CITY OF ISANTI SPECIAL MEETING OF THE PLANNING COMMISSION TUESDAY, May 17, 2022 6:00pm CITY HALL

A. Request by Semler Construction Inc for approval of a Planned Unit Development Preliminary Plat under City Ordinance 740, said request is for a 44-lot housing development named Rum River Villas located at PID 16.111.0600.

SUBJECT: Preliminary Plat for Rum River Villas

Subject: Rum River Villas – Site Plan, Stormwater Management Plan & Preliminary Plat Review

Concept Plan for Rum River Villas Preliminary Plat

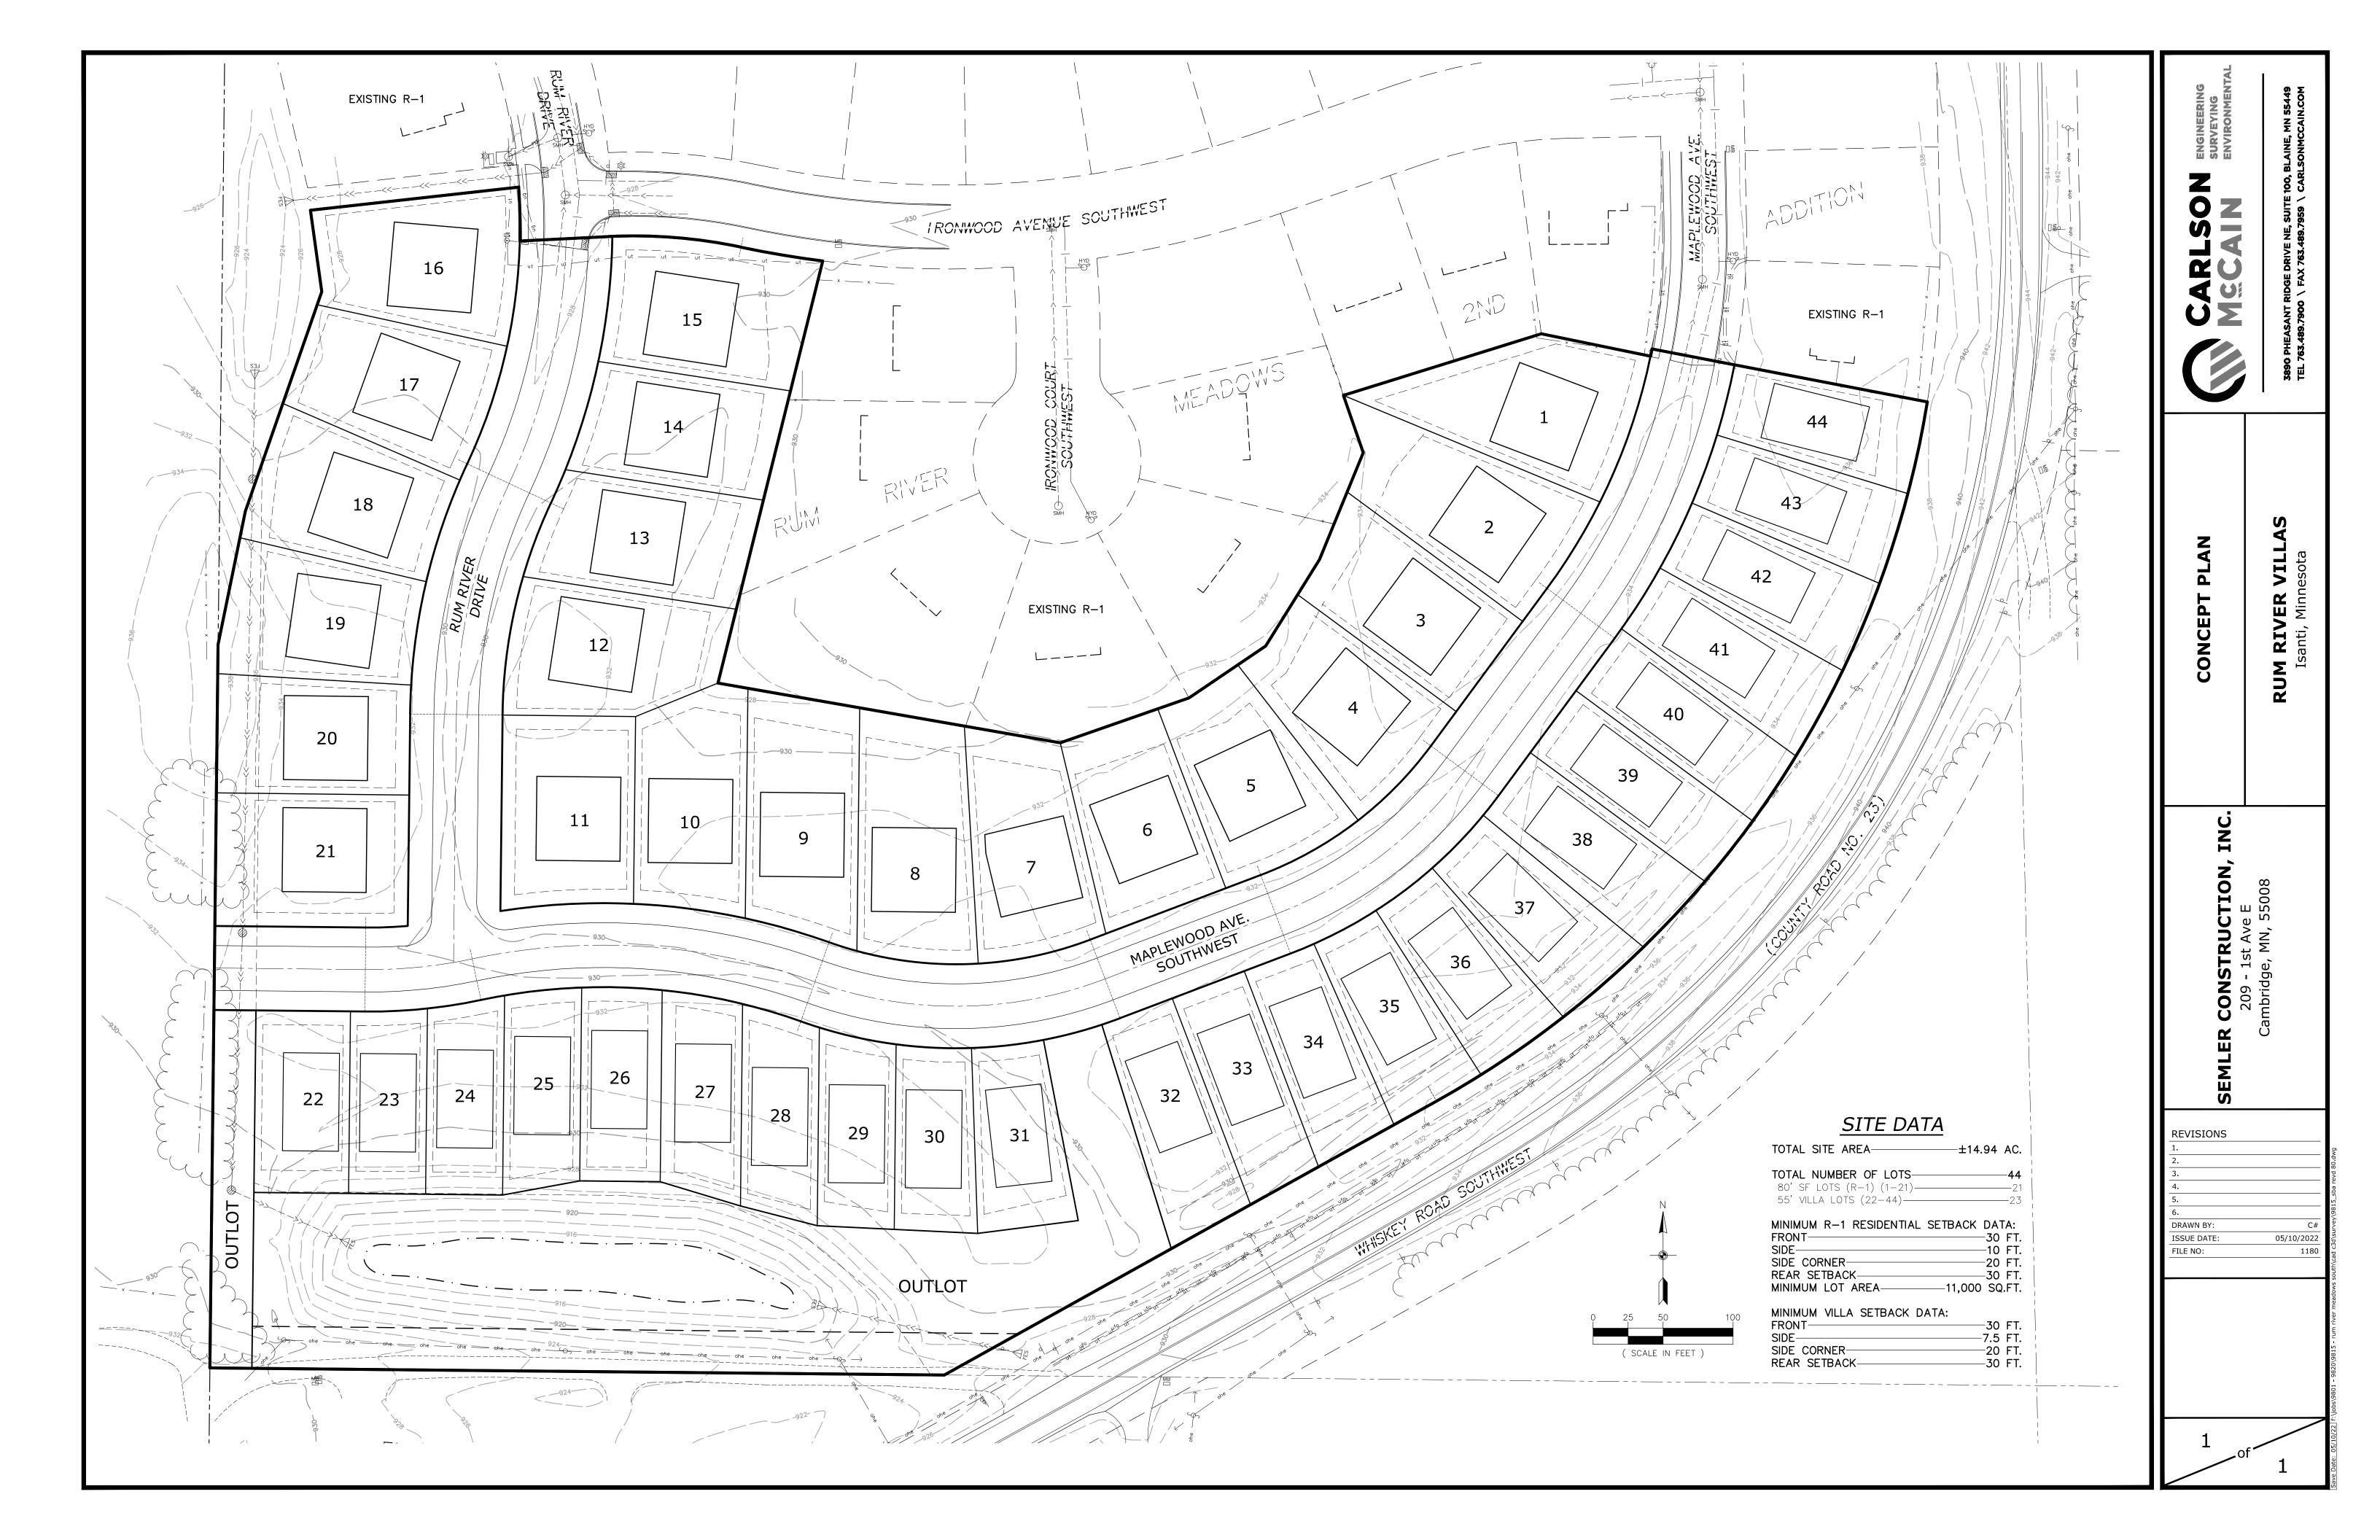
On April 19, 2022 the City of Isanti Planning Commission held a Public Hearing for the Preliminary Plat for Rum River Villas as requested by Semler Homes. The plat that was originally presented consisted of 53 homes as allowed by City Ordinance under Planned Unit Developments for a 20% increase in density in relation to the current zoning district. Upon direction from the Public Hearing aforementioned, Semler Homes has altered their request to consist of 44 homes as allowed in the current density for the zoning district R-1 Single Family Residential. The PUD ordinance allows for an alteration in lot sizes as long as they meet the minimums required within overall residential districts within City Zoning Ordinance.

The attached concept follows the rules and requirements of a PUD allowed in the R-1 Sing Family Residential District.

Staff recommends approval of the Preliminary Plat as long it meets all conditions outlined by the City Engineer and City Staff presented at the previous meeting. Previous Memos are attached.
